# STAFF RECOMMENDATION

**NCPC File No. ZC 07-13**

## **RANDALL JUNIOR HIGH SCHOOL REDEVELOPMENT CONSOLIDATED PUD AND MAP AMENDMENT**

December 27, 2007

**SITE PERSPECTIVE LOOKING SOUTHEAST  
(CORNER OF HALF AND H STREETS, SW)**

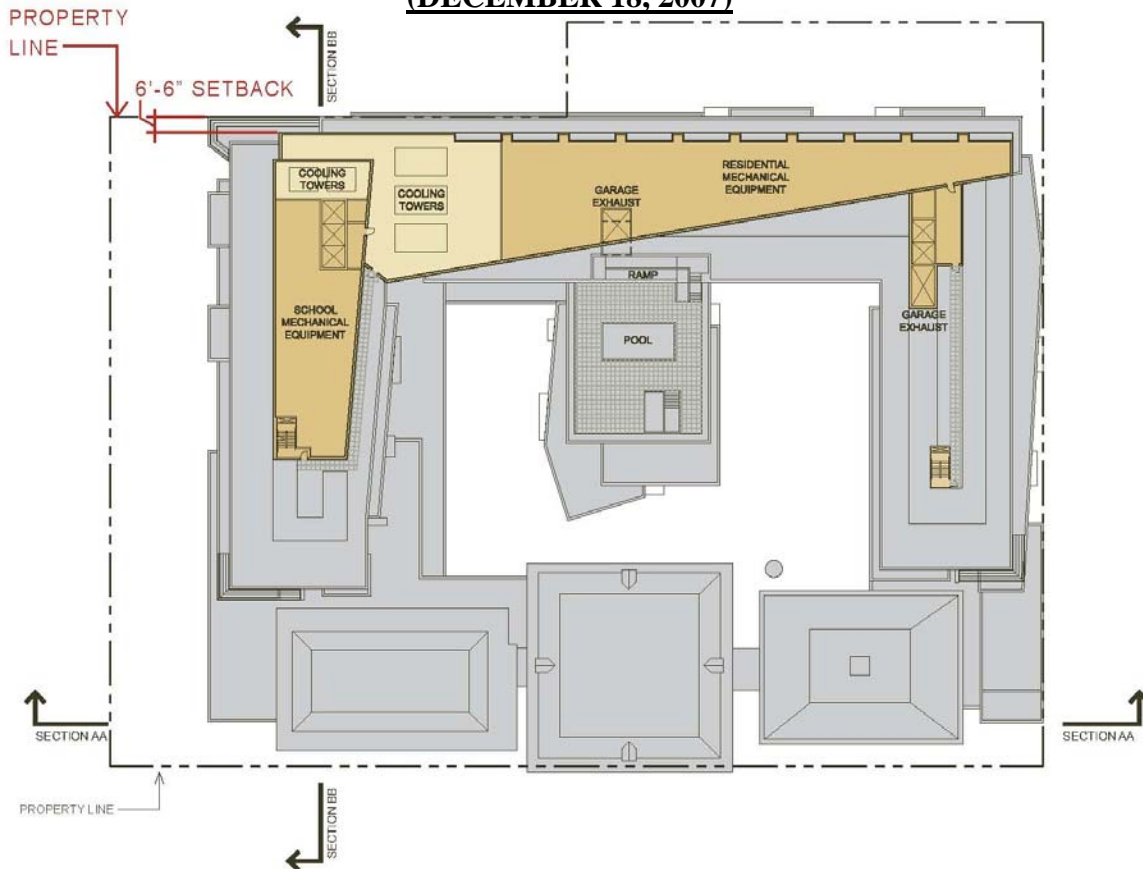
The northern mechanical penthouse is only setback six feet and six inches from the edge along H Street which is not sufficient, according to the Height of Buildings Act. Because the penthouse is not set back properly from the building wall, it is included in the overall height of the building, which is 116 feet, or six feet greater than the 110 feet that is permissible under the Height of Buildings Act for this project.

The developers of this property submitted revisions to their drawings at the December 10, 2007 Zoning Commission meeting and addressed the penthouse issue (see image on the next page, right). Their proposal at the December 10<sup>th</sup> Zoning Commission meeting was to redesign the northern penthouse by moving it back four feet from the facade. While the Zoning Commission proposed to approve the project with the four foot setback, they discussed increasing this setback to at least six feet. Zoning Commission members considered this six-foot distance in lieu of the four foot dimension because it is the difference between the actual height of the northern penthouse, which is 116 feet, and the allowable maximum height of the building under the Height of Buildings Act, which is 110 feet, the theory being that only the portion of the penthouse that exceeds the allowable overall building height need be set back. NCPC staff does not concur that this approach would meet the requirements of the Height of Buildings Act and maintains that the entire penthouse structure must be set back a distance equal to its height above the roof.

As staff believes that the conformance to the Height of Buildings Act issue has not been resolved by either the previous re-designs or the plans submitted on December 18, 2007, **we recommend that the Commission comment to the Zoning Commission that the applicant should modify the design to set the penthouse back from the building wall to a distance equal to its height.**
